Federal Emergency Management Agency

This is in reply to your letter of December 13, 1982, regarding potential inadequacies for notification of the public using the Michigan Warren Dunes State Park, in event of a nuclear emergency at the D. C. Cook Nuclear Plant.

Enclosed is a drawing of the proposed installation site and coverage area. Each center line represents 3,000 feet. This system is to produce sound that would be 115 decibels at the source and 70 decibels at the outer fringe area of the drawing. Ambient background is 58 decibels without persons on the beach.

Enclosure

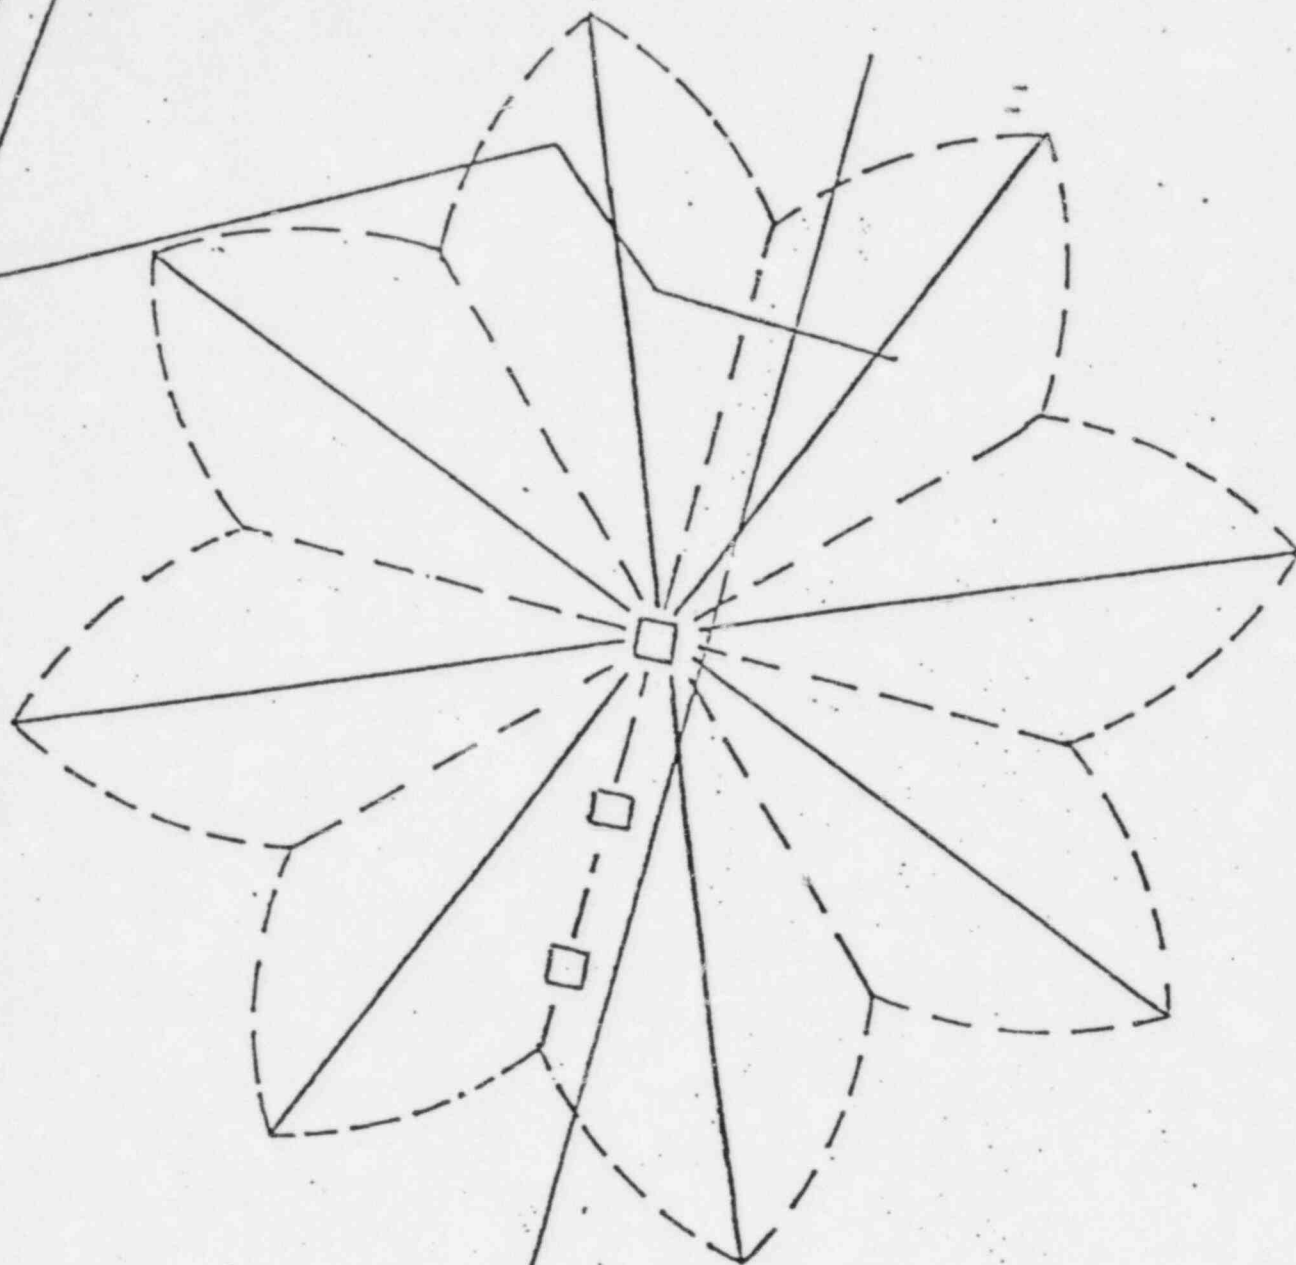
Based on review of the enclosed drawing and the map submitted by Mr. Southwood with his letter of October 29, 1982, the proposed system would be adequate to warn all individuals along the beachfront and

others within one-half mile radius of the sirens. It is noted the park presently has one mobile PA system (in vehicle 16-669) which will be used to alert persons in the campground. The second mobile PA system (in vehicle 13-957) is to be used to alert persons in the picnic areas outside the distance of the centrally mounted sirens. Each vehicle would serve as back-up to the other during maintenance, although this would contribute toward longer notification times.

We believe the proposed system will be adequate to warn essentially 100 percent of the people within the Warren Dunes Park area.
